Tasniah Fabrics Ltd. (9886)

25.MAY.2014

Identified Priority 2 Concerns

2nd Priority 2 Concern

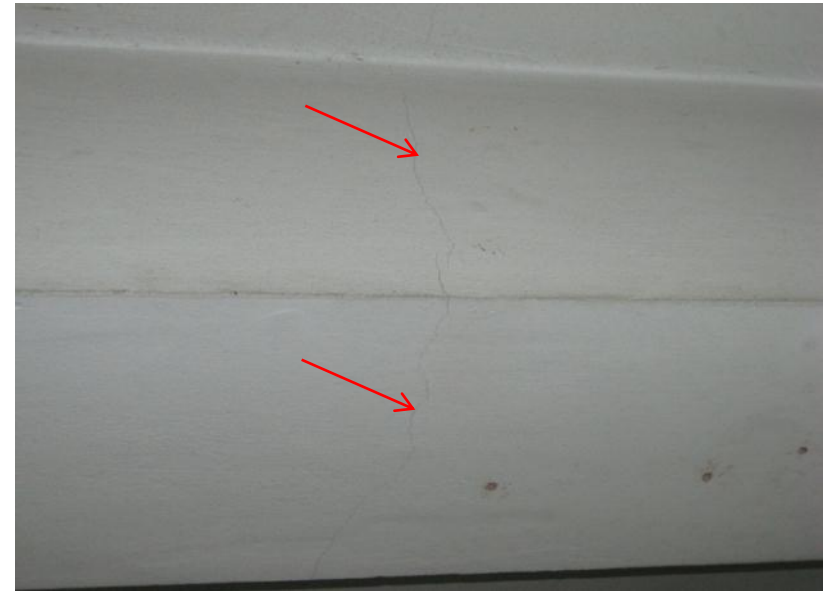
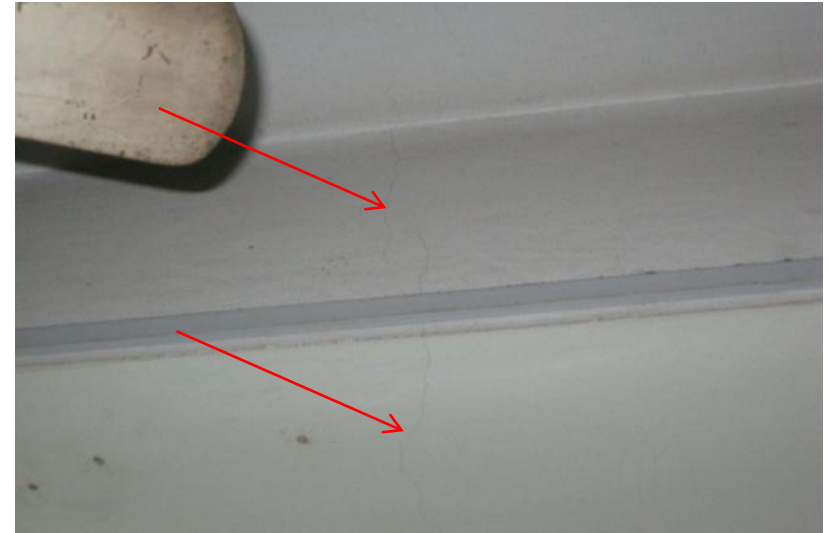
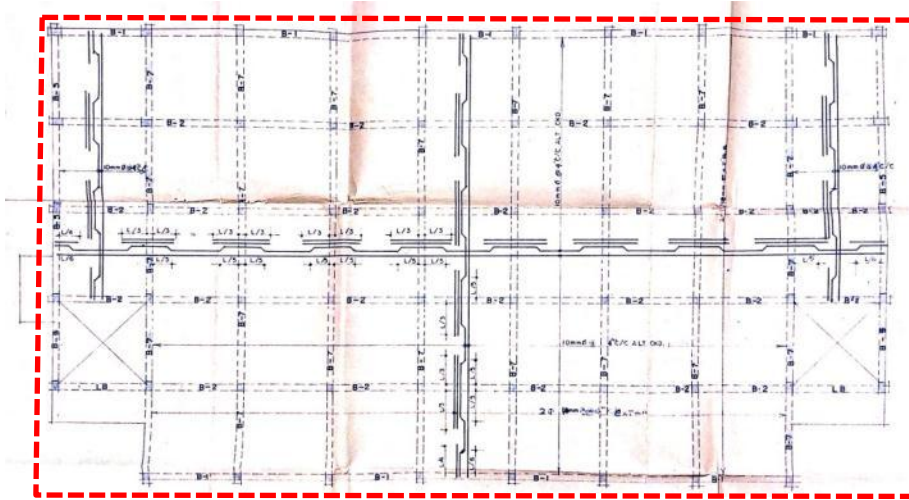
Cracks appeared underside beam and slab on 2nd and 3rd floor, capacity check is required prior to repairing.

3rd Priority 2 Concern

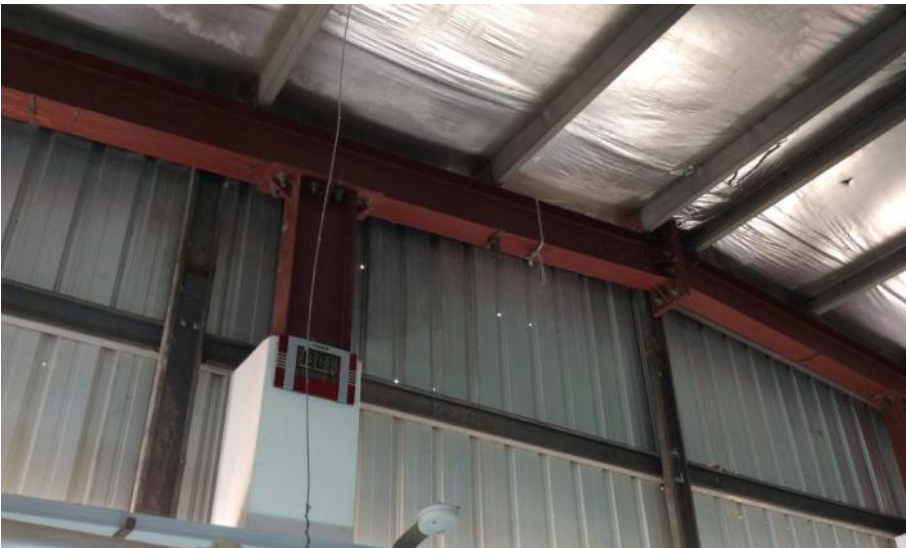
There is no structural drawings provided and insufficient lateral steel bracing. Capacity check is required.

4th Priority 2 Concern

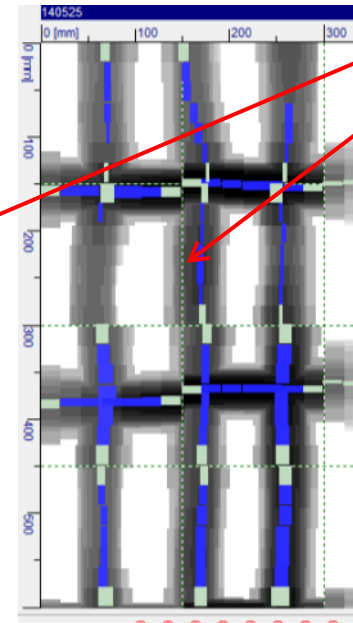
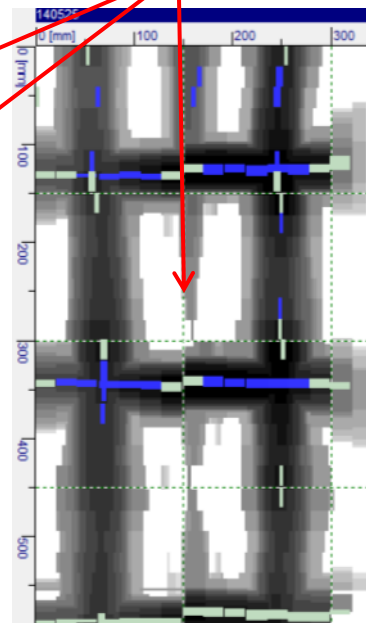
The number of re-bars detected appear to be fewer than those specified on the construction drawings.

Long Side: 3-16mm.

Short Side: 3-16mm.

4th Priority 2 Concern

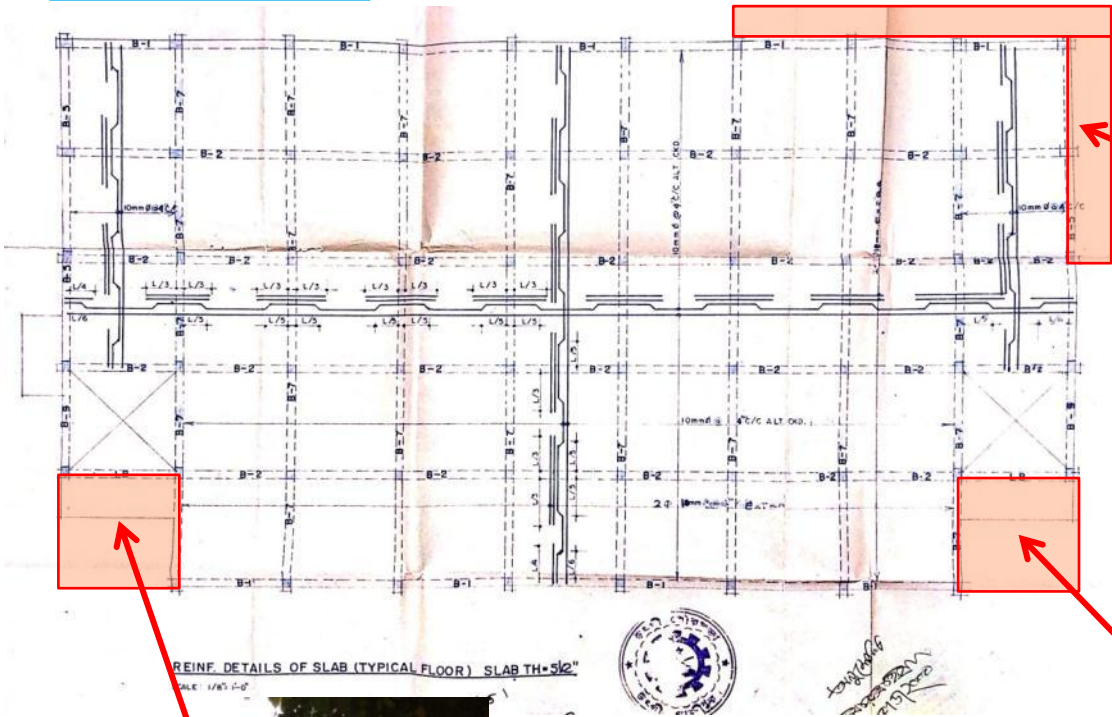
There are cantilevered slabs and beam on 1st to 3rd floor levels that do not appear on the structure drawings. Capacity checks are required.

5th Priority 2 Concern

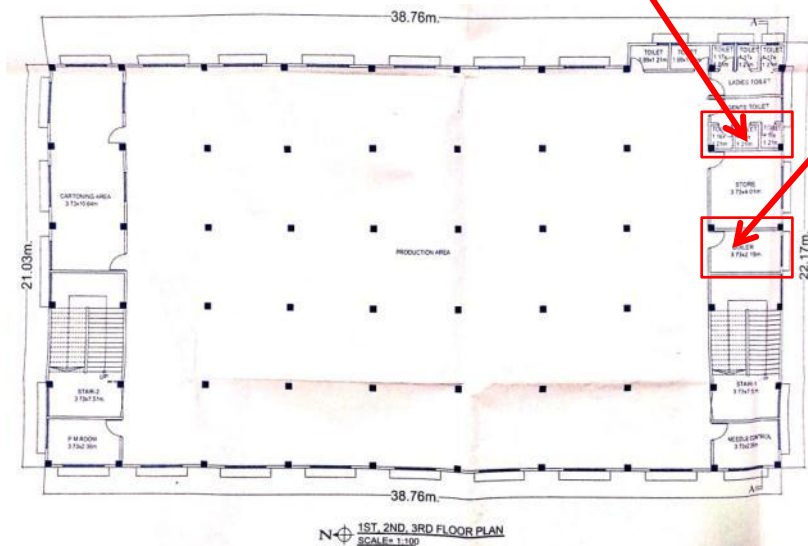
There are no structural support for water tank, capacity check is required.
